Historic Preservation Commission Meeting

January 07, 2026

LOT 51 - BLUE CRAB PRIVATE
RESIDENCE

Cover letter addressing plan review comments for COFA-09-25-019927
Lot 51,4 Blue Crab Road – Tabby Roads

A5.1

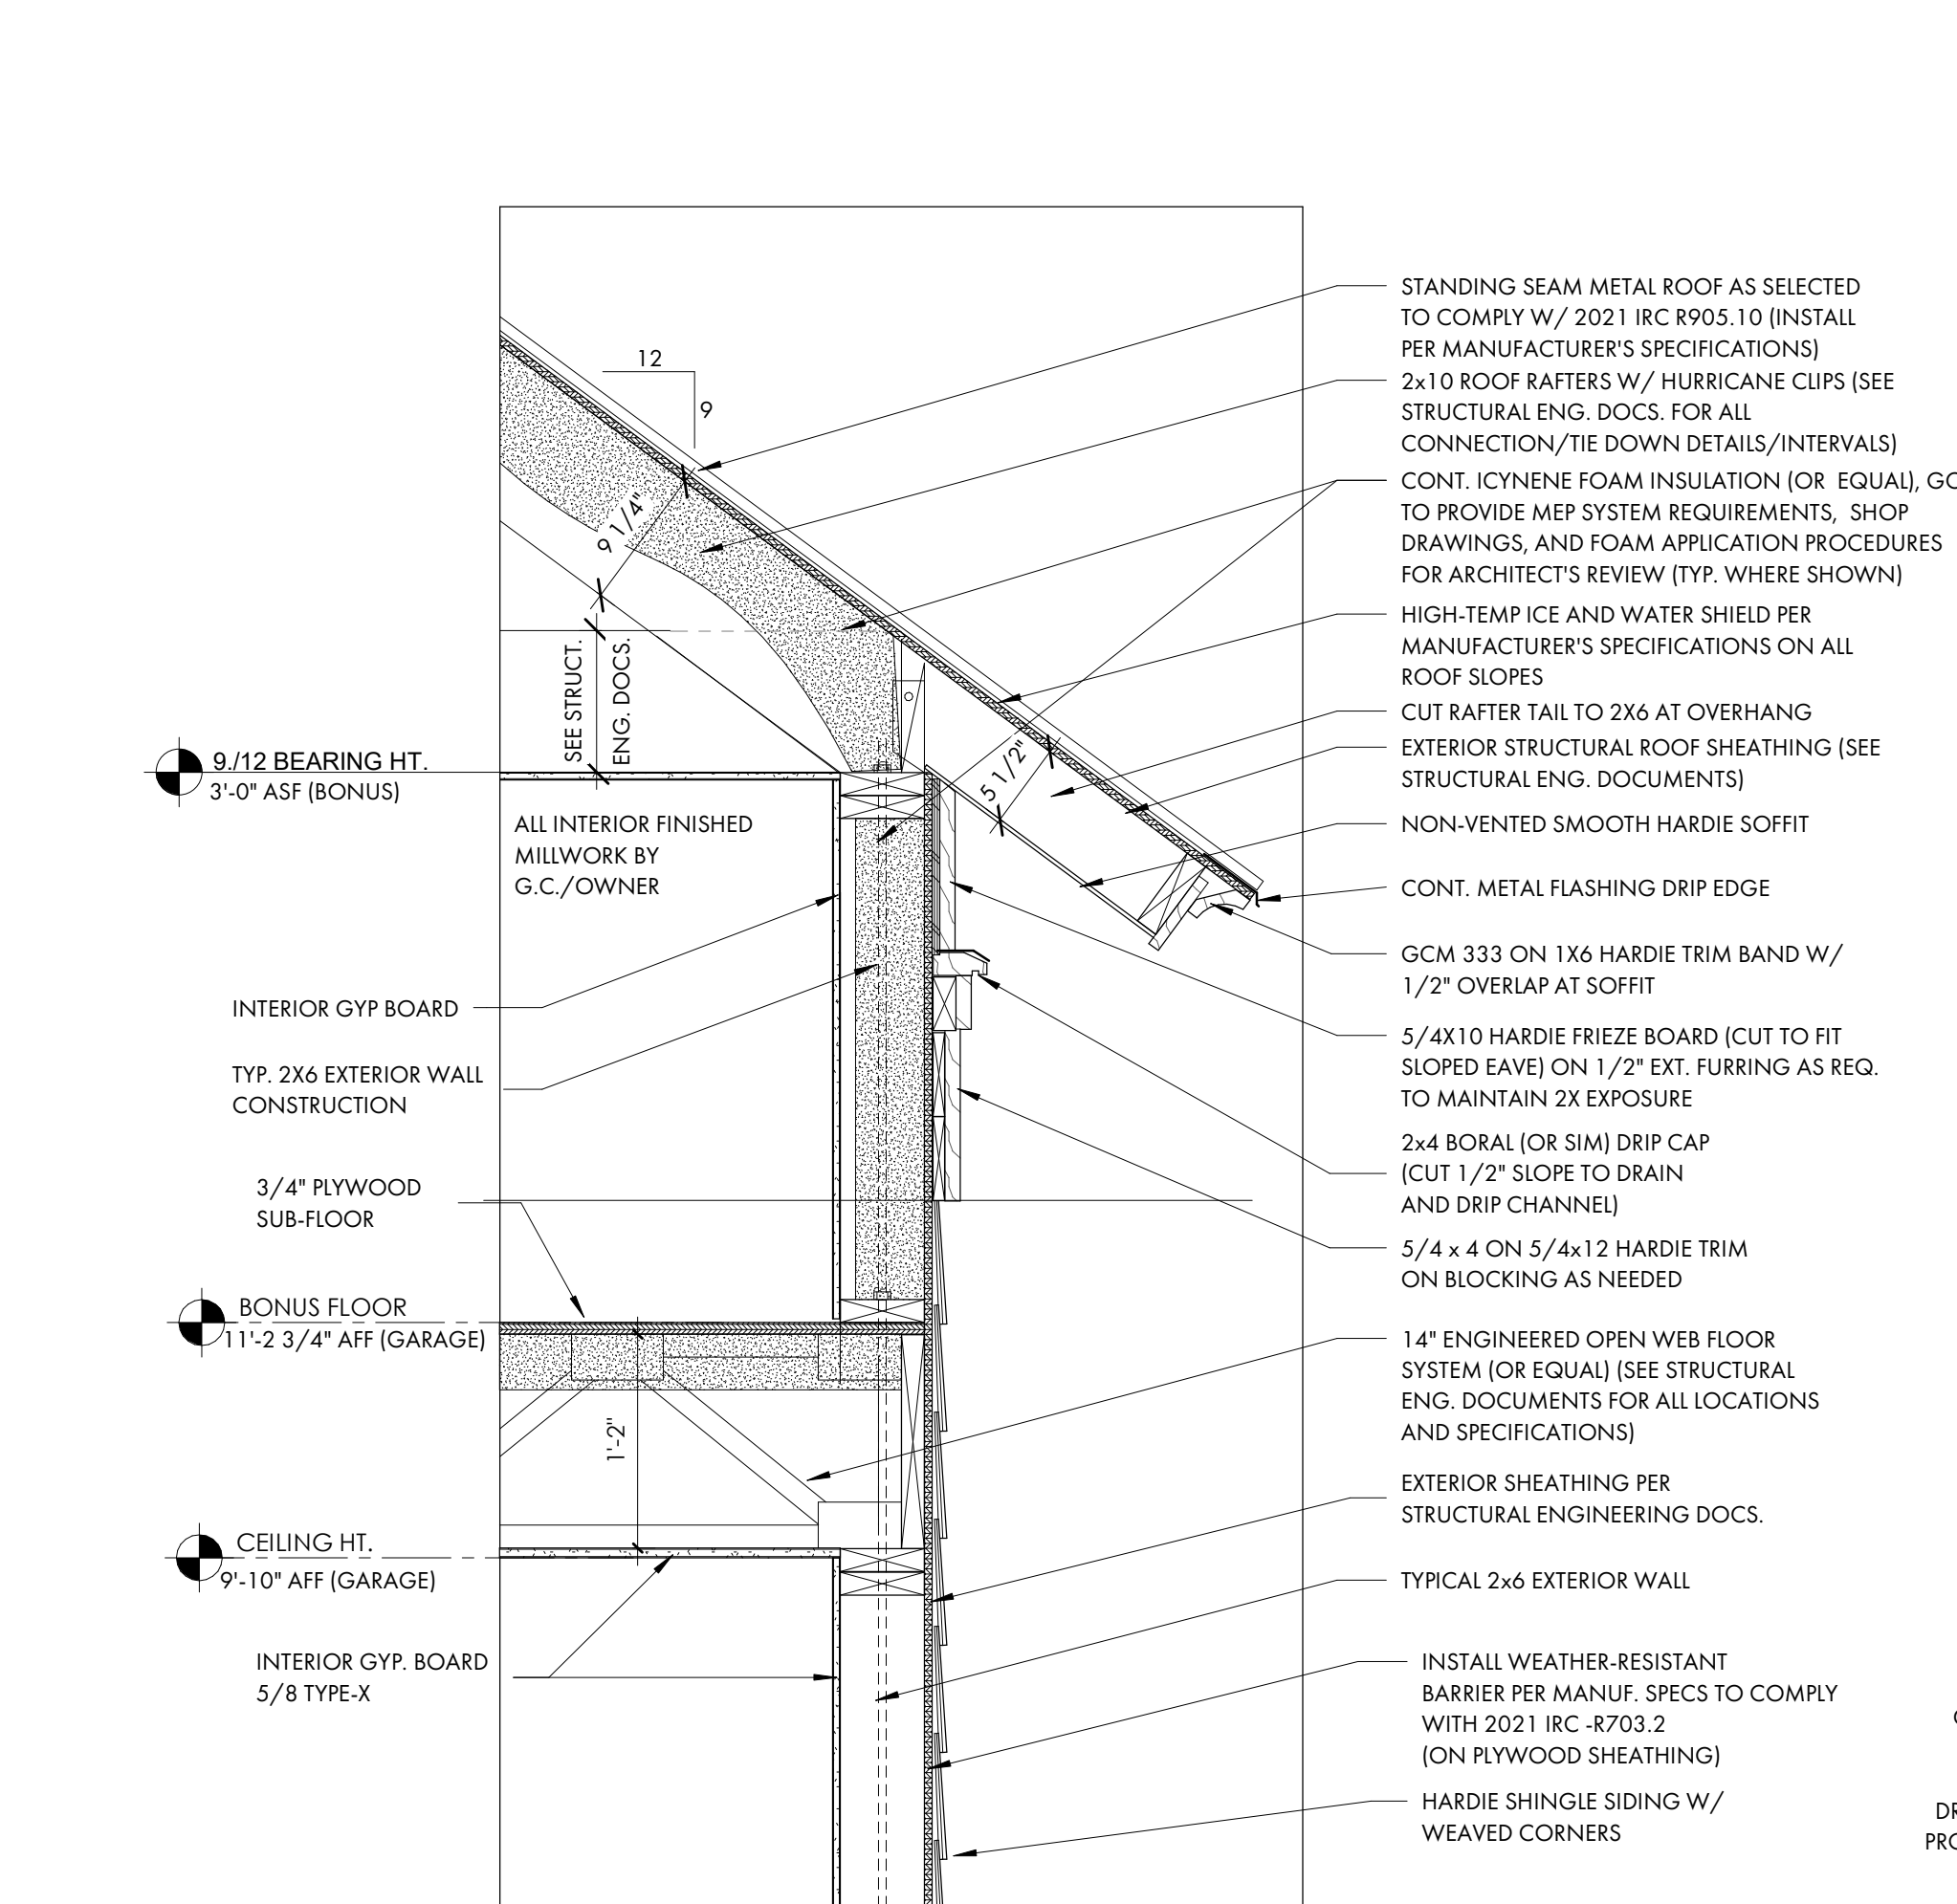
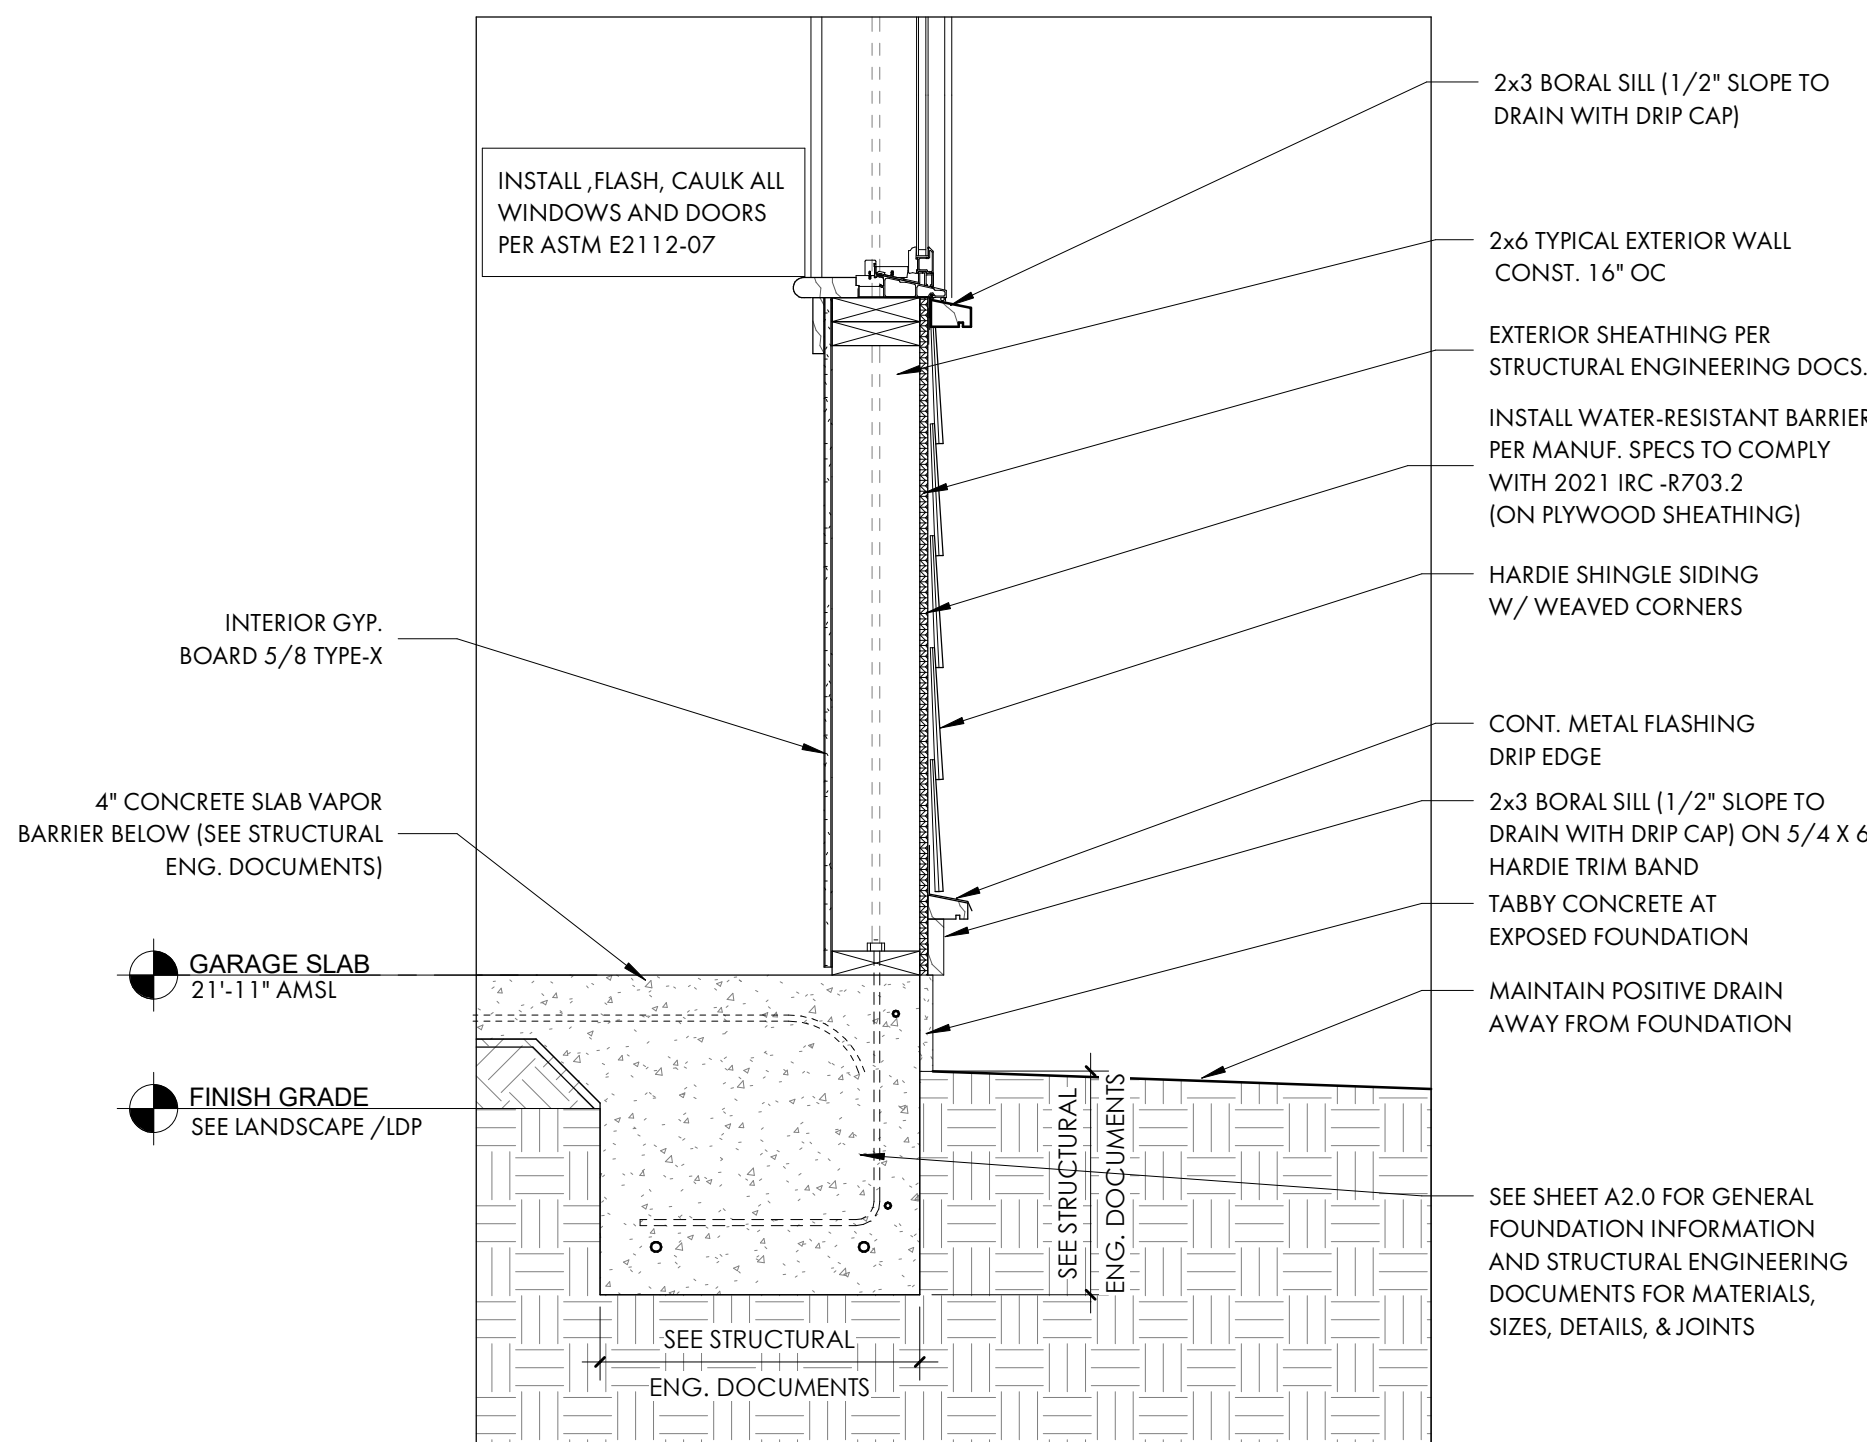
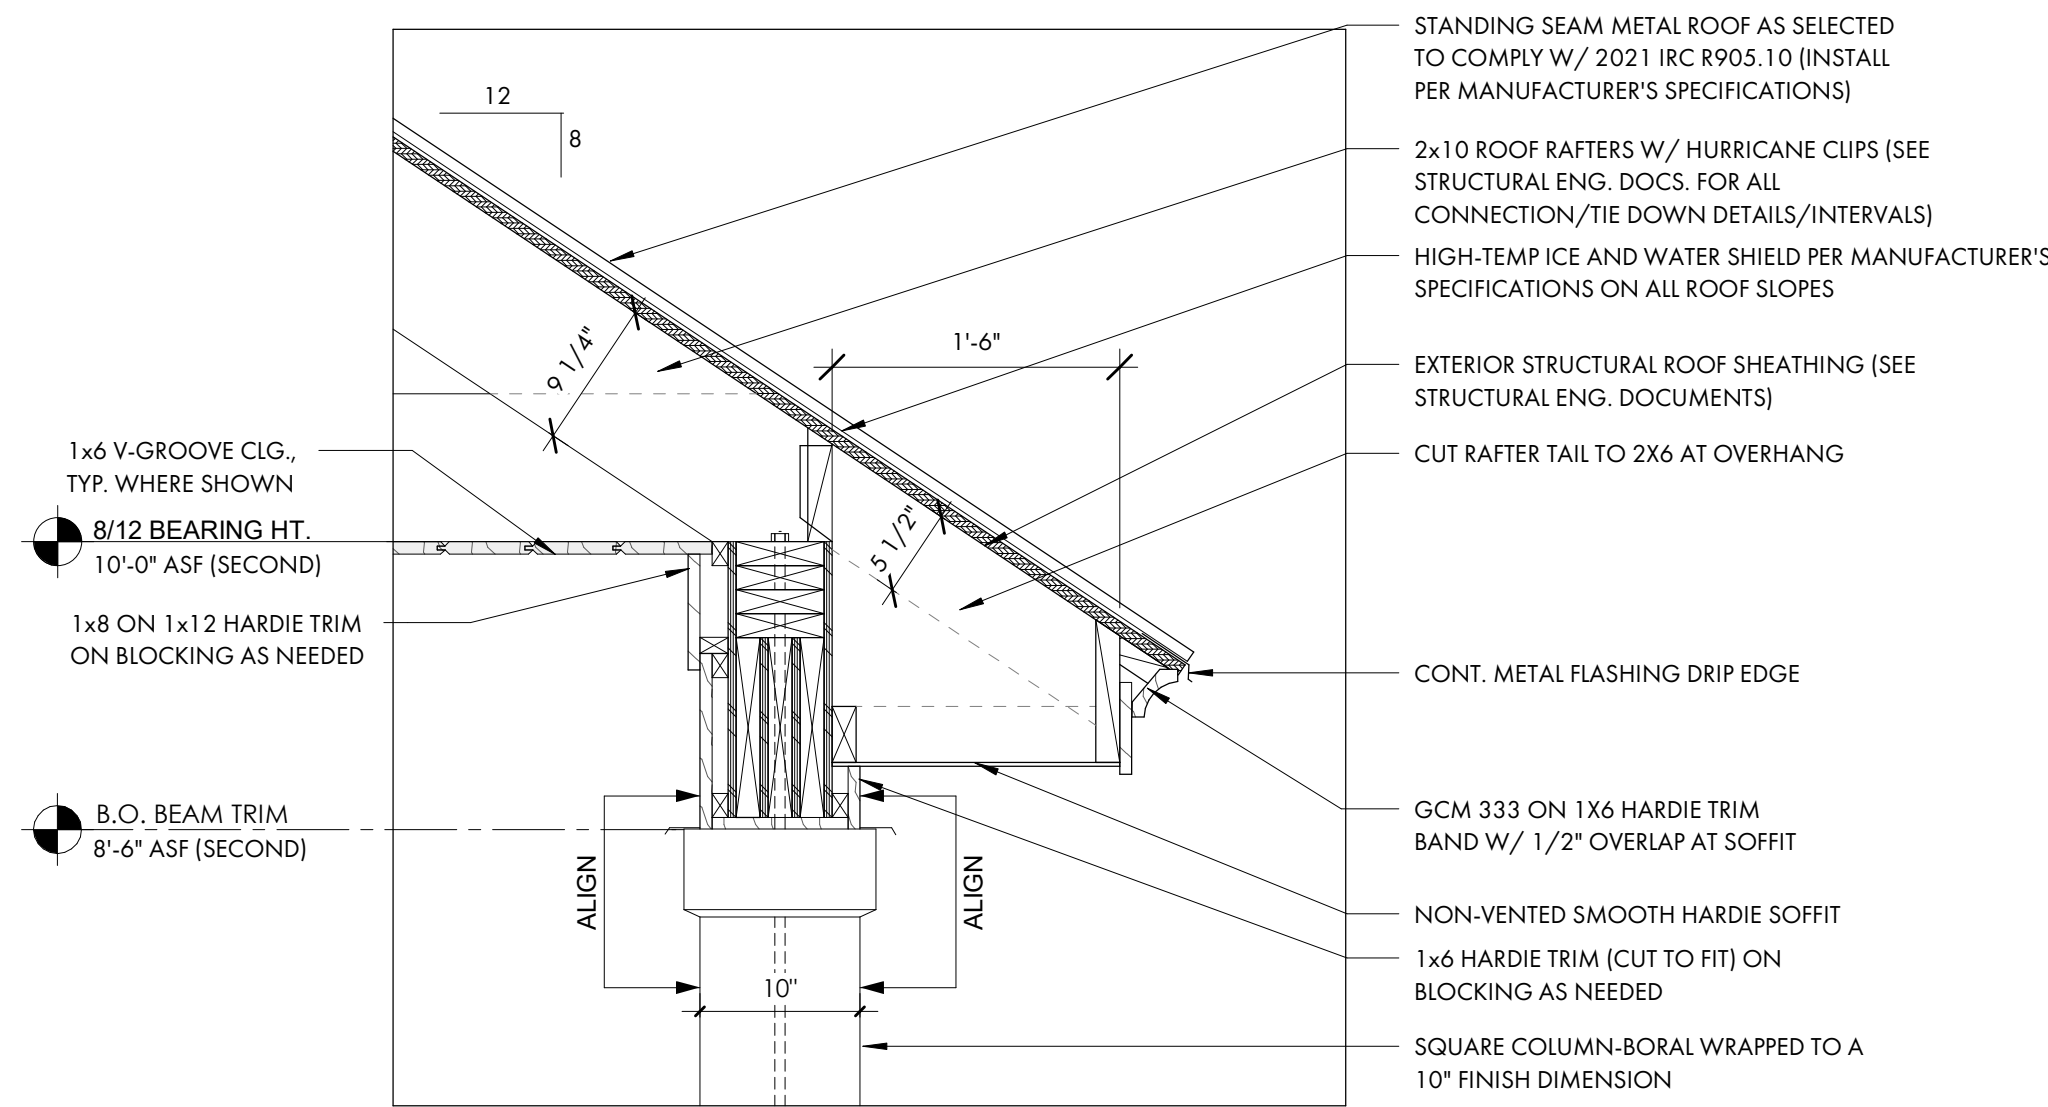
- **Please see detail sheet A5.0 clarifying the porch fascia details and identity of the porch ceiling material**
13. Second Concept Plan Review: Given the number of comments, a second Concept Plan review will be required.

We have updated the garage water table detail to suggest a 5/4x6 versus 5/4 x 4 trim band to match the main house. See sheet A5.1
